**SUBJECT: Final Well Abandonment Plan for the Inhibited Red Fuming Nitric Acid (IRFNA) Site (SEAD-13), Seneca Army Depot Activity, Romulus, New York; Contract W912DY-08-D-0003, Delivery Order 0002**

## **FINAL WELL ABANDONMENT PLAN**

## Army's Response to Comments from the United States Environmental Protection Agency

**Subject:** Draft Final Well Abandonment Plan  
Inhibited Red Fuming Nitric Acid (IRFNA) Disposal Site (SEAD-13)  
Seneca Army Depot  
Romulus, New York

FIGURE 1-3  
 SEAD-13 IRFNA Disposal Site  
 Historical Groundwater Elevation Plan  
 April 2002

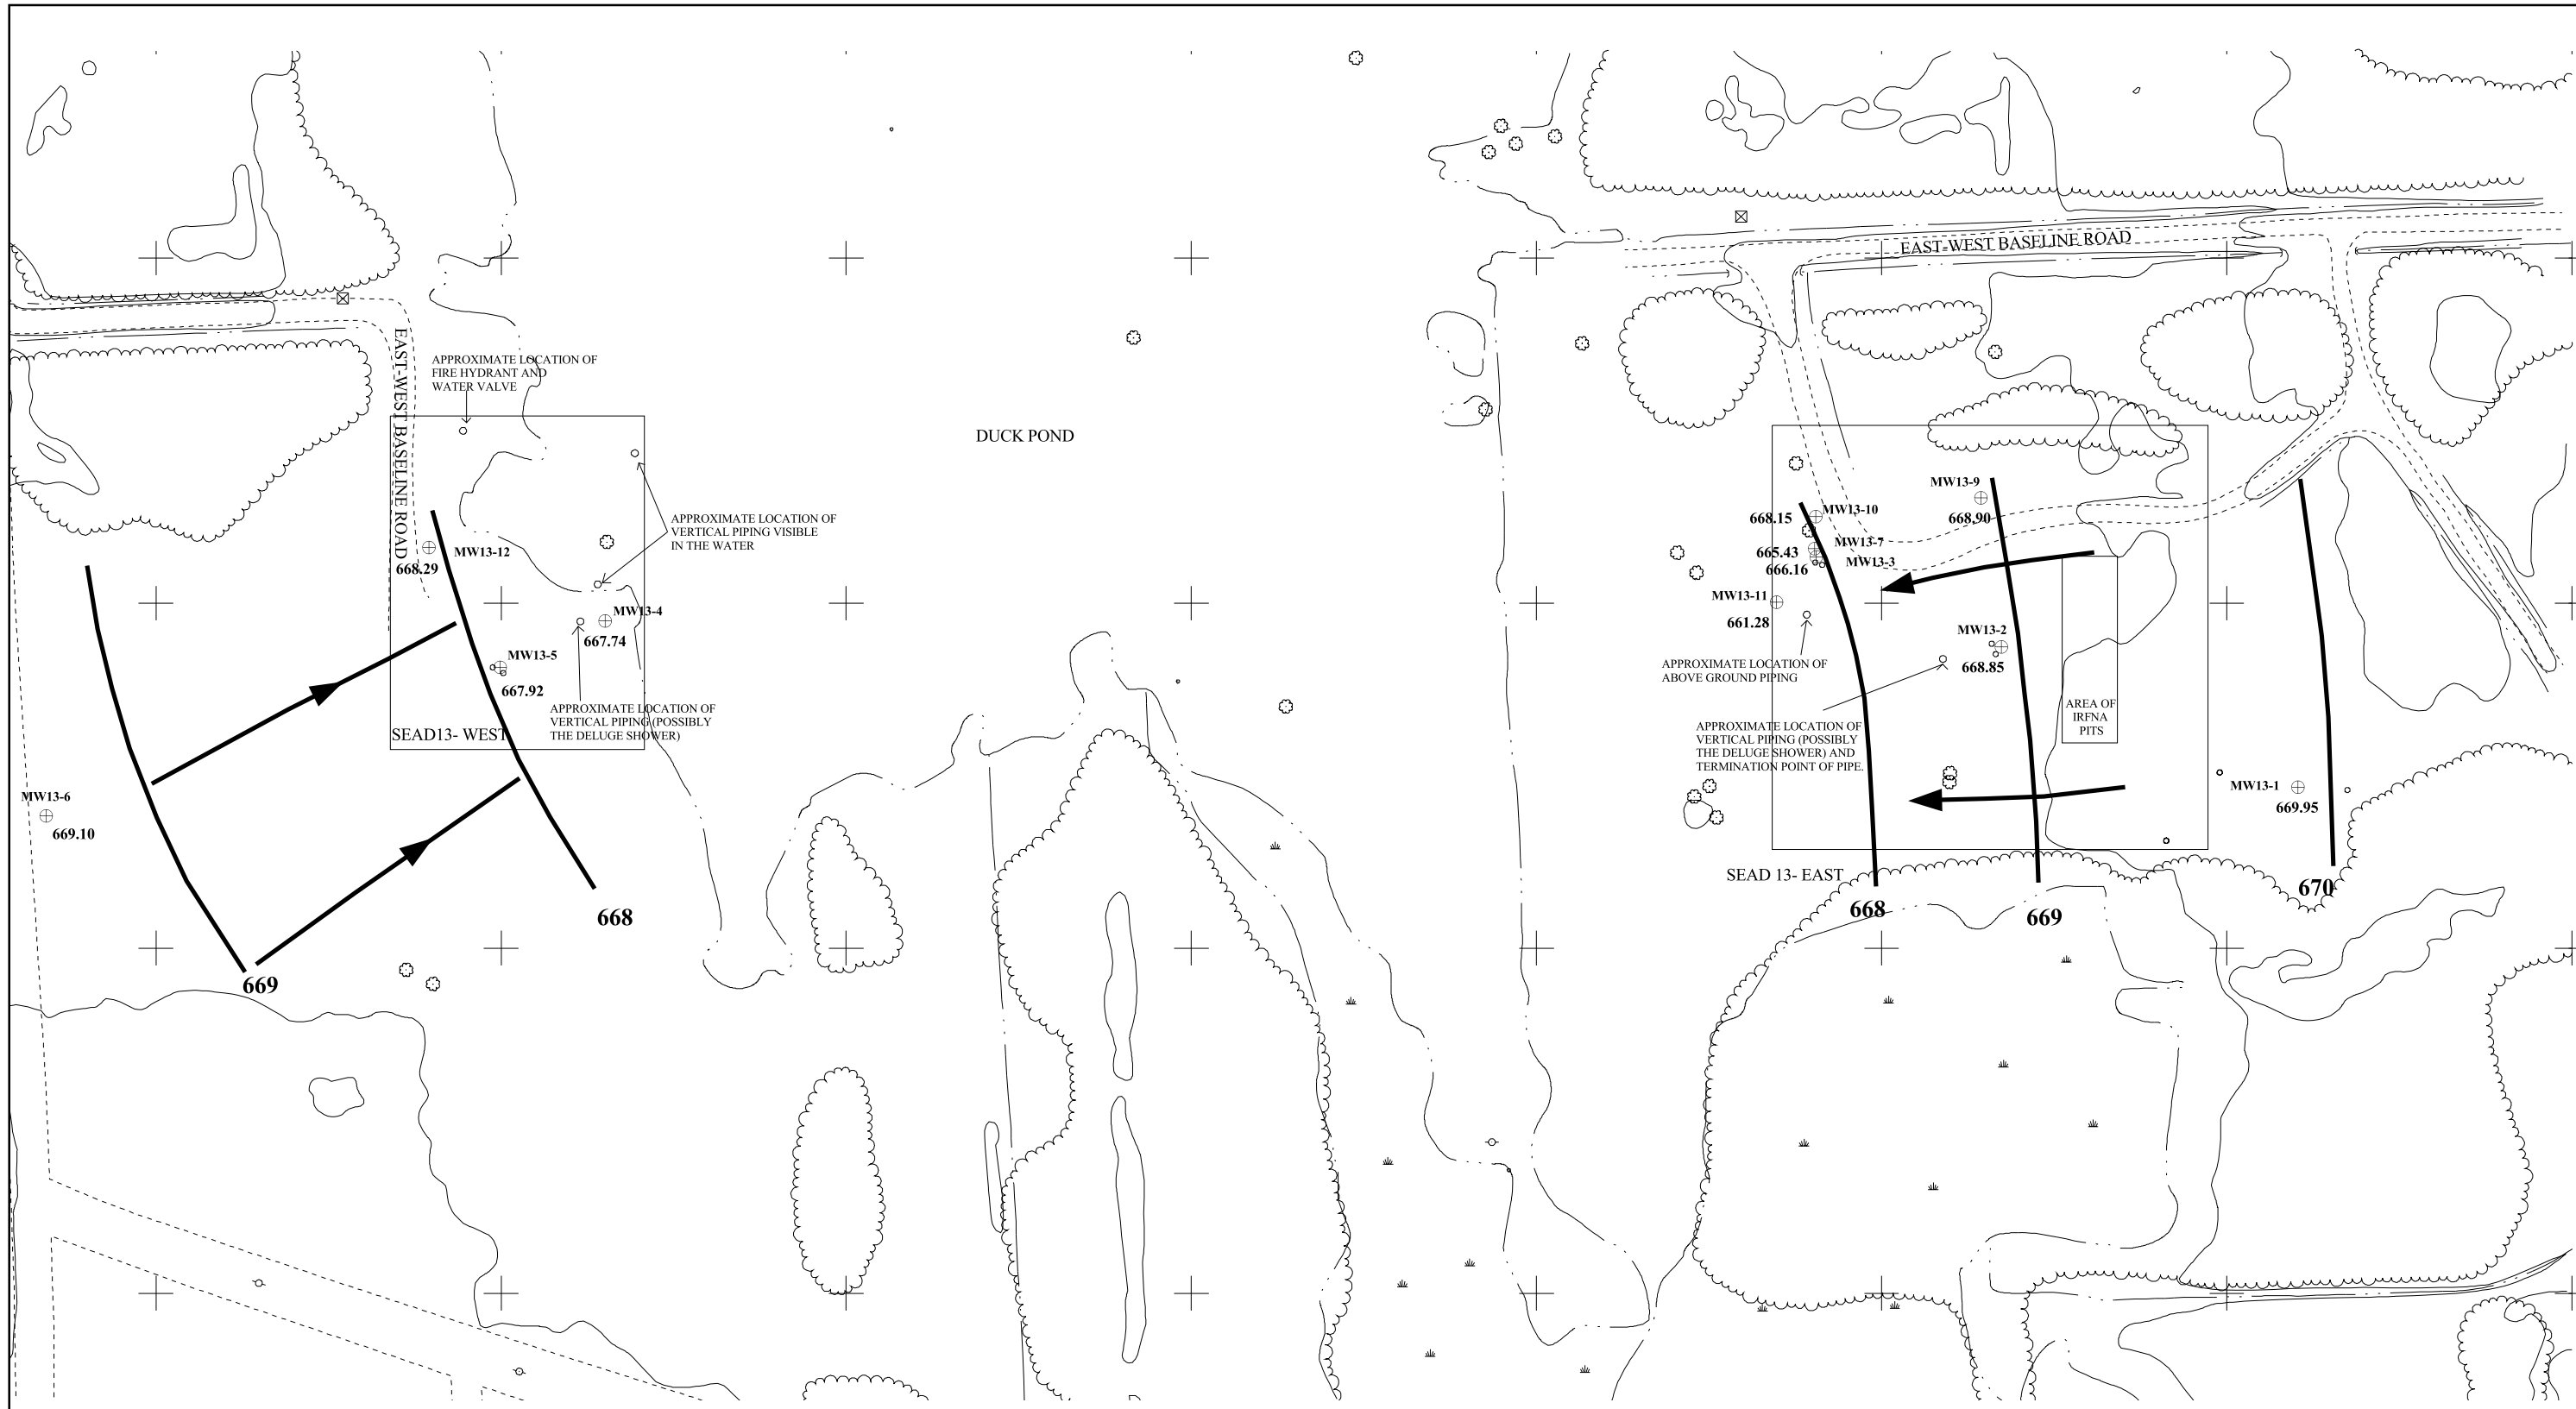
**Comment 3:** Figure 1-3, SEAD-13 IRNFA Disposal Site, Historical Groundwater Elevation Plan, April 2002: The symbols used to depict the monitoring well locations do not correspond to the monitoring well symbol in the legend. Revise the figure to use a consistent symbol both on the figure and in the legend.

**Response 3:** Figure 1-3 will be revised so that the monitoring well symbol used in the legend and in the figure are the same symbol.

**FIGURE 1-4**

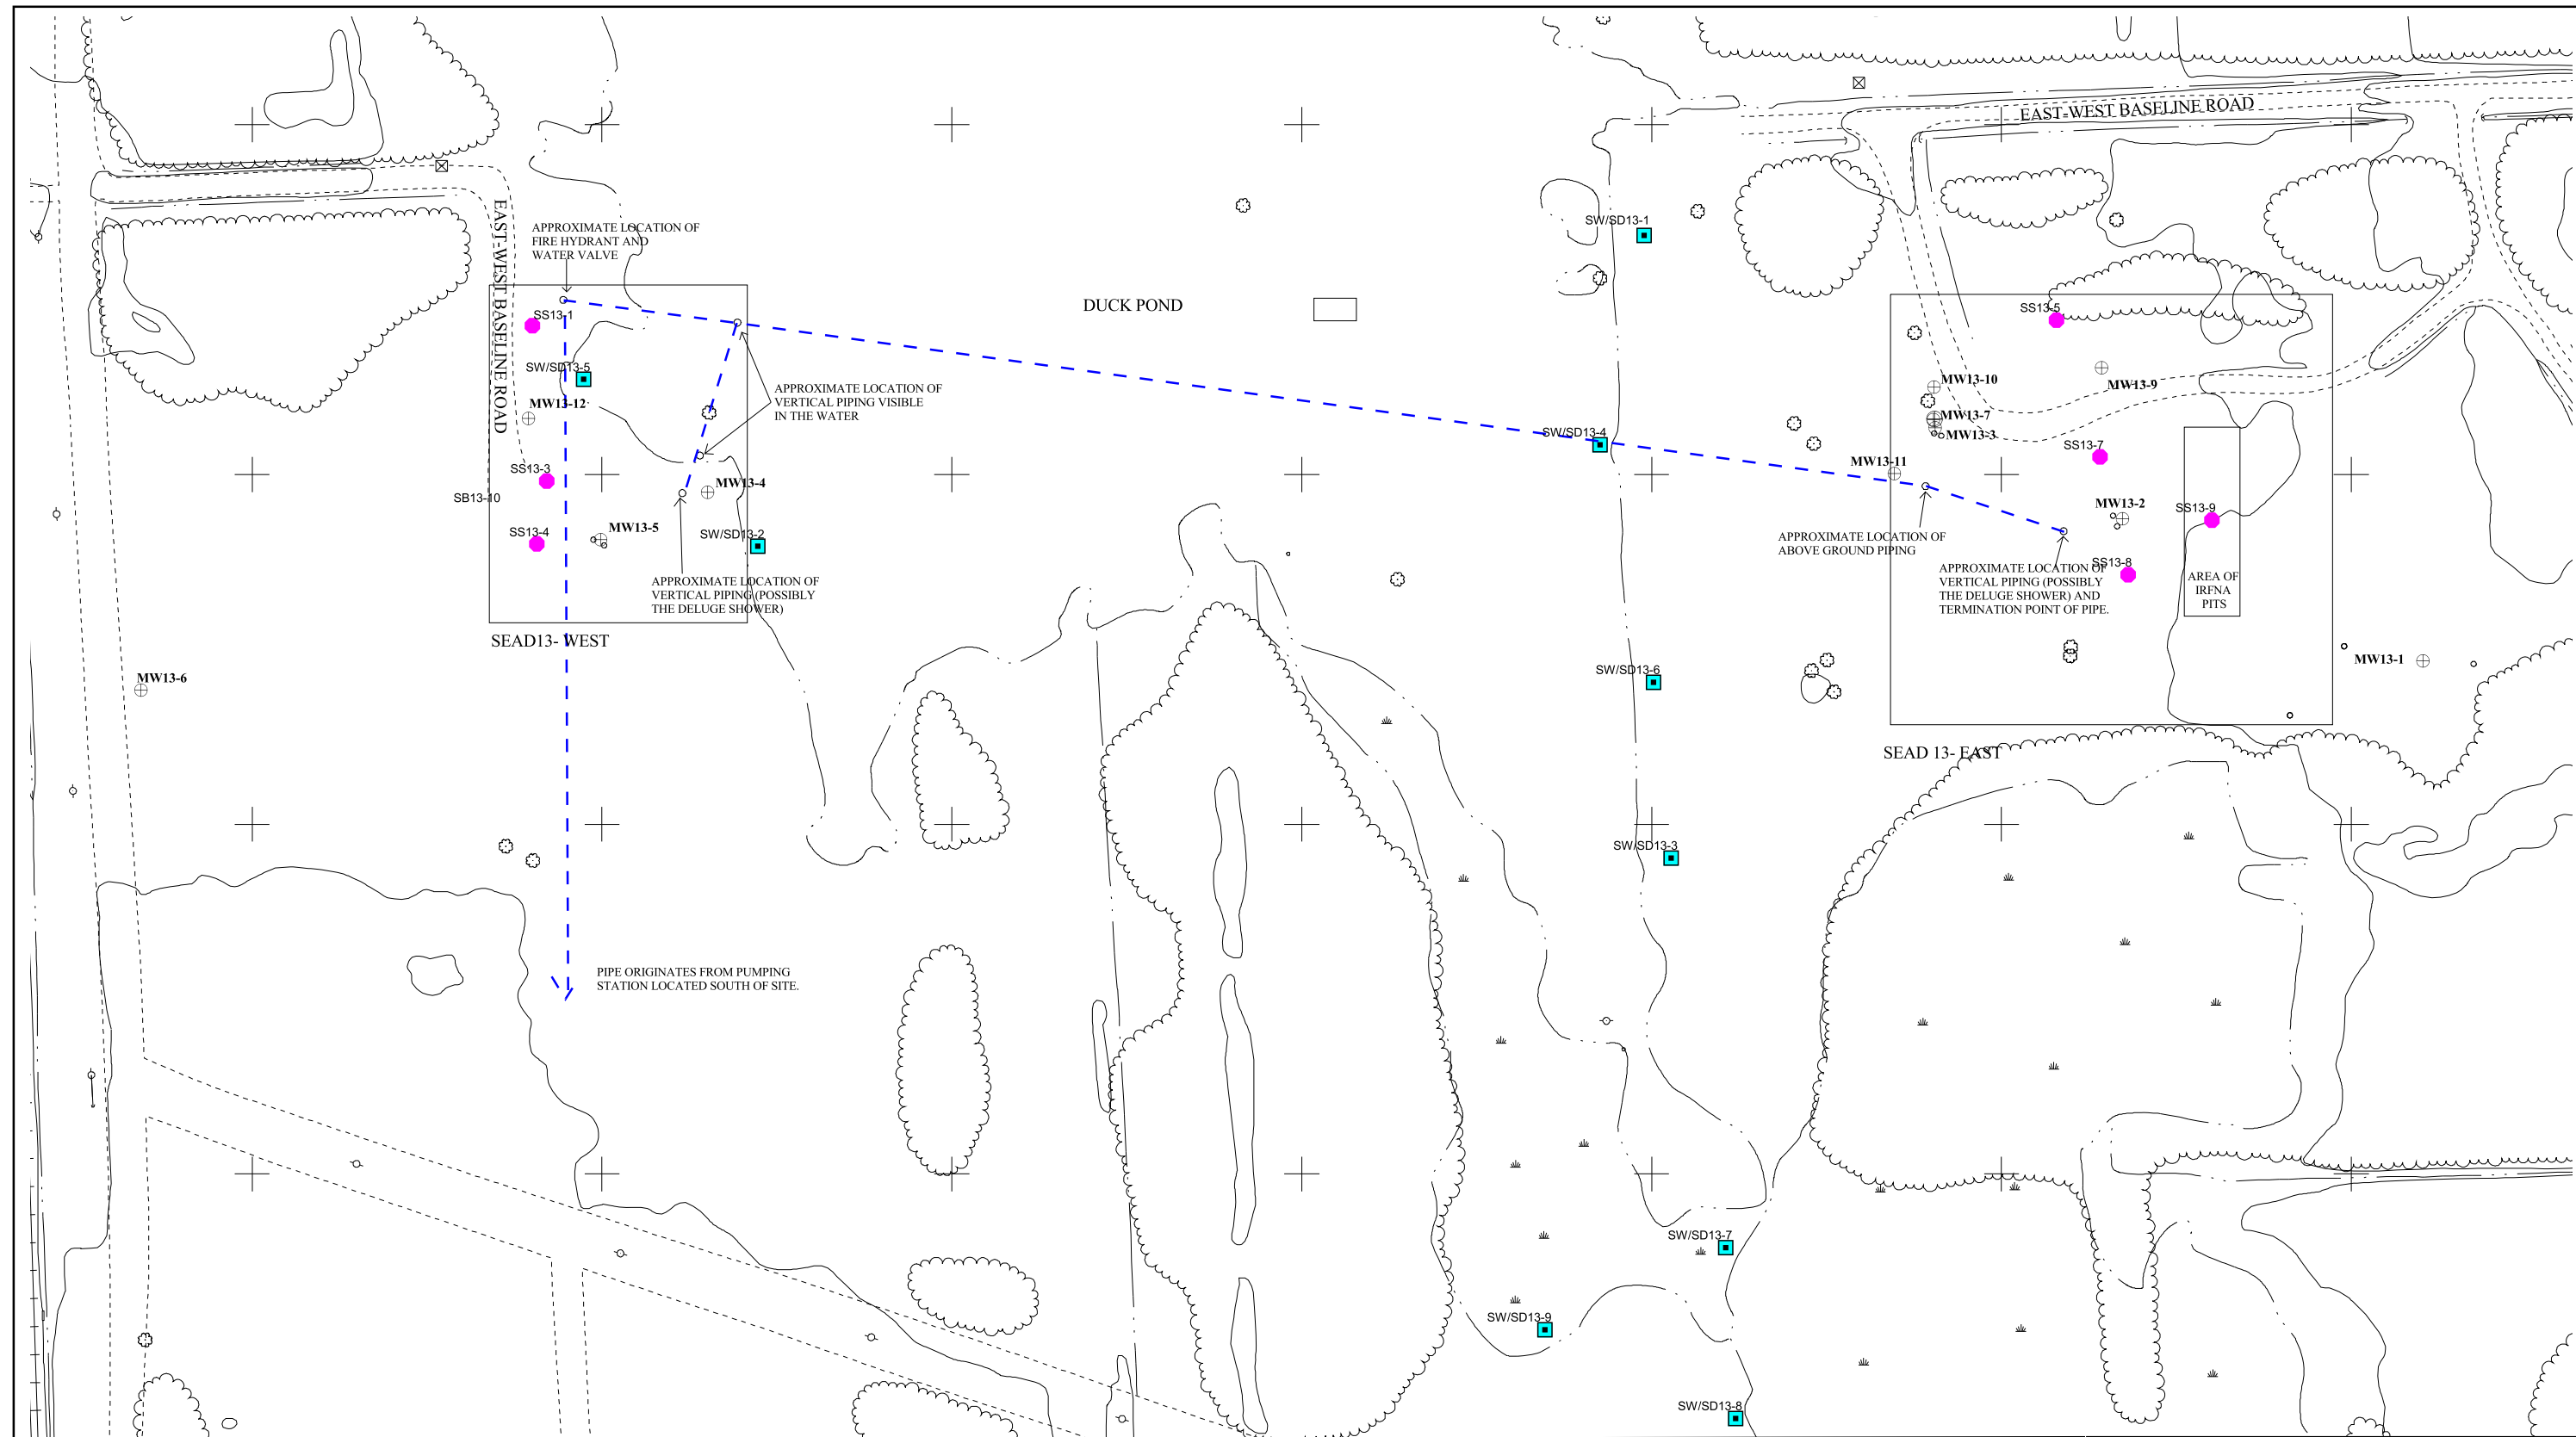
**Comment 4:** Figure 1-4, SEAD-13 IRNFA Disposal Site, Historical Sampling Locations: The symbols used to depict the monitoring well locations do not correspond to the monitoring well symbol in the legend. In addition, what appears to be the location of MW13-7 in the area of SEAD-13 East is not clearly shown. Revise the figure to use a consistent symbol both on the figure and in the legend and clearly label the location of MW13-7.

**Response 4:** Figure 1-4 will be revised so that the monitoring well symbol used in the legend and in the figure are the same symbol. The monitoring well labels will be revised so they are viewable.
